Re: Notice of Civil Penalty Assessment and Order
Case No. WQ/I-ER-2021-186

Memorandum

Subject: Groundwater: *Log Yard Dye Tracer Study Results - Boise Cascade Elgin Complex, Elgin, Oregon*, dated November 16, 2022; *Elgin Complex, 2022 Annual Report, WPCF 103020*, dated February 2023; Groundwater Quality Review – Boise Cascade Log Yard, Elgin, Oregon, dated July 7, 2023.

Figure 1. Groundwater Contours – February 2022

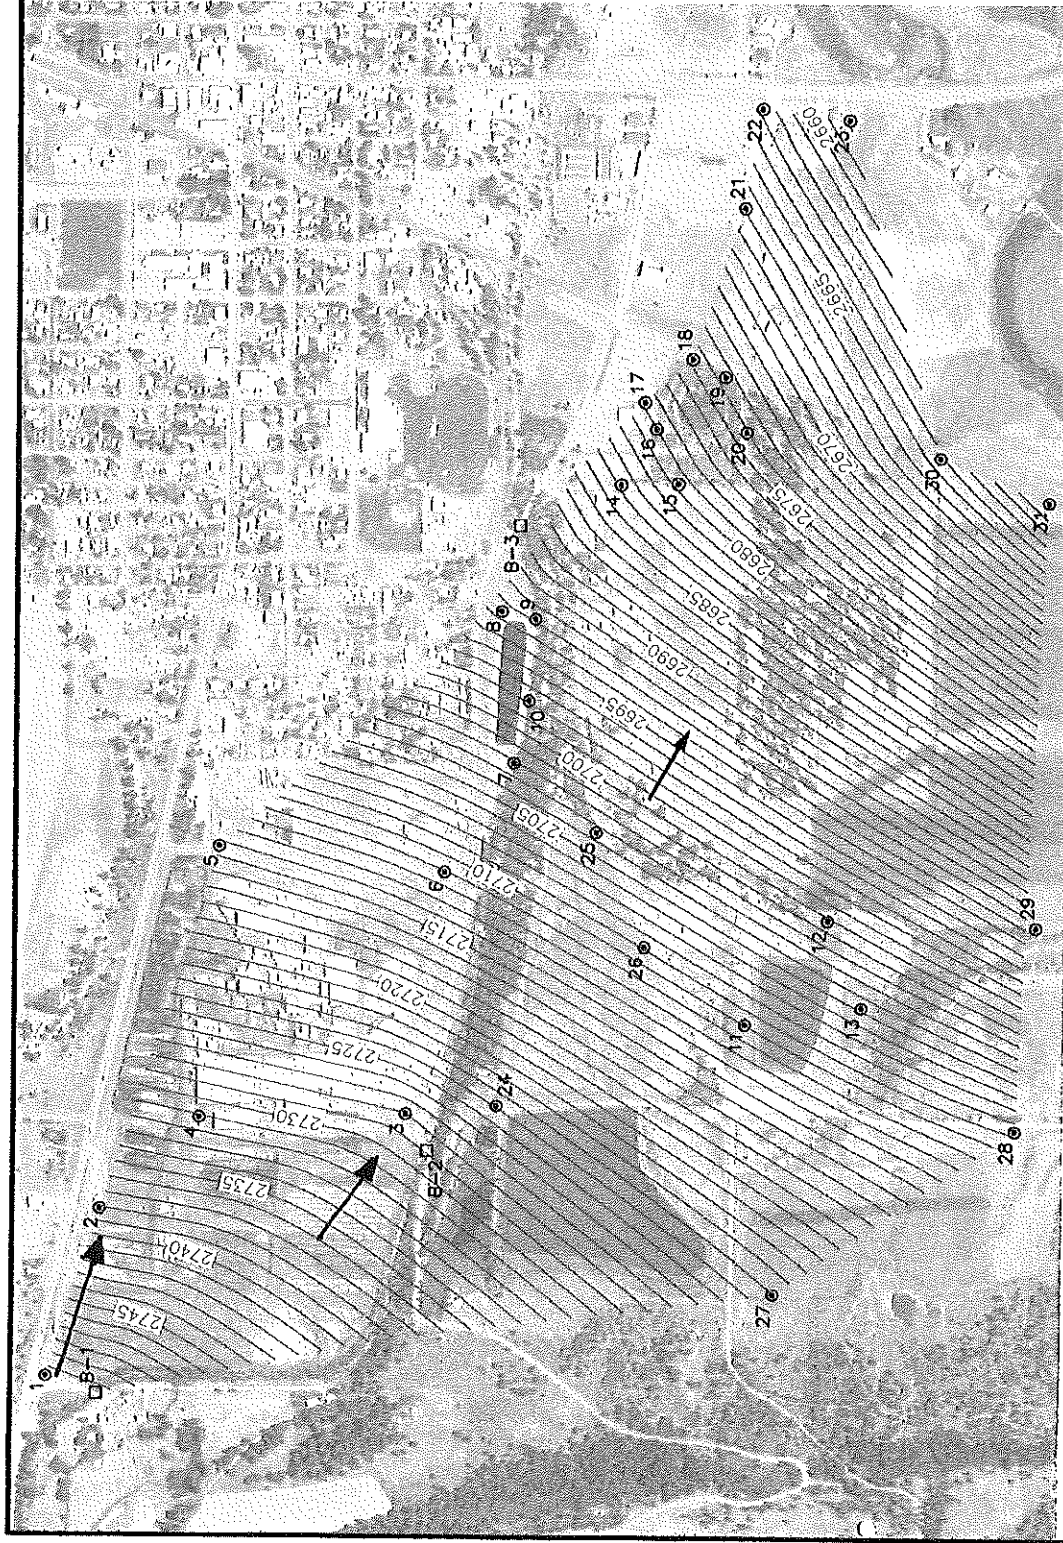
Based on the elevation at MW-1 it is the highest groundwater elevation at the log yard. However, based on the groundwater contour maps at the site, groundwater flow at MW-1 is going slightly south of east generally north of or possibly towards MW-2. Groundwater flow at MW-2 is generally either going north of MW-5 or possibly somewhat towards MW-5. The groundwater contours indicate groundwater flow moving through MW-1 is generally skirting along the northern boundary of the site or even moving off site to the north. This is not a good upgradient well for most of the log yard. Groundwater flow near monitoring well MW-4 is generally slightly south of east to nearly due east. The flow at MW-4 is generally heading a little south of MW-5. On the south side of the site MW-3 and MW-6 generally show flow going south of east. There does not appear to be a good upgradient well that is on a flow path with these wells. Moreover,

the groundwater flow at these wells is highly questionable because there is no shown connection with the creek. Any connection to the creek will likely have a significant influence on flow near these wells. See attached contour maps.

The contour maps provided for the site do not appear to provide an accurate flow of groundwater at the site. Significant numbers of water level data points are identified as suspect and not included in the contour maps. For example, the contour maps show elevations for 31 wells and three elevations from the creek; however, in the contour maps from 2022 significant numbers of the measurements are flagged as suspect and not used in the contour maps. The maps state that suspect values are eliminated for clarity. Elimination of large numbers of control points is not providing clarity but instead biasing the contours showing incorrect flow in many areas of the site. In the contour maps for 2022, 26% to 68% of elevations were not used in the quarterly contour maps. There was no explanation for why the data were suspect. Having such a large percentage of unused elevations is unacceptable, without a valid reason. An accurate contour map with flow directions cannot be produced using only 32% to 74% of the elevation data. Some of the data points appear to be consistently flagged and removed, but some points are used sometimes and not others. All data points including the elevations from the creek must be used to illustrate accurate flow at the site. Boise will need to conduct a thorough evaluation of the wells and provide rationale for not using data and propose replacement wells and creek measuring points if necessary.

Based on groundwater contours and flow paths from the contours, there is little chance that groundwater flow in the vicinity of MW-1 makes its way anywhere close to any of the wells other than a possible minor influence at MW-2. The groundwater flow pattern at MW-1 indicates flow in this area is skirting along the northern boundary and is an unsatisfactory representation of upgradient conditions for the log yard.

Represented groundwater contours across the entire site generally do an unsatisfactory job of representing flow conditions at the site. The flow cannot be accurately represented without incorporation of significant elevation control points including the creek elevations. Based on some of the omitted elevations it appears that the groundwater contours should be showing the creek as a gaining stream at the location of B-2 and B-3. It is less clear in the vicinity of B-1. The contour maps generally ignore the creek elevations and cut straight across the creek, indicating there is no connection with the creek. Additionally, many other elevations are omitted from the contour maps. Many other groundwater elevations are frequently omitted with no reason given for the "questionable" data. The facility must provide adequate justification for elimination of any of the elevations from the contour maps.

It is likely that additional monitoring wells may be needed to accurately contour the groundwater flow at the site. However, prior to adding more wells the facility must accurately contour the available data. Because of the chronic omission of water level elevations, it would seem the facility should resurvey the wells and creek measuring points to ensure there is not survey error with the existing water levels. Once resurveyed an accurate contour map using all the elevations must be produced. Once a reasonable contour map for the site is produced, DEQ will evaluate the need for additional wells at the site.
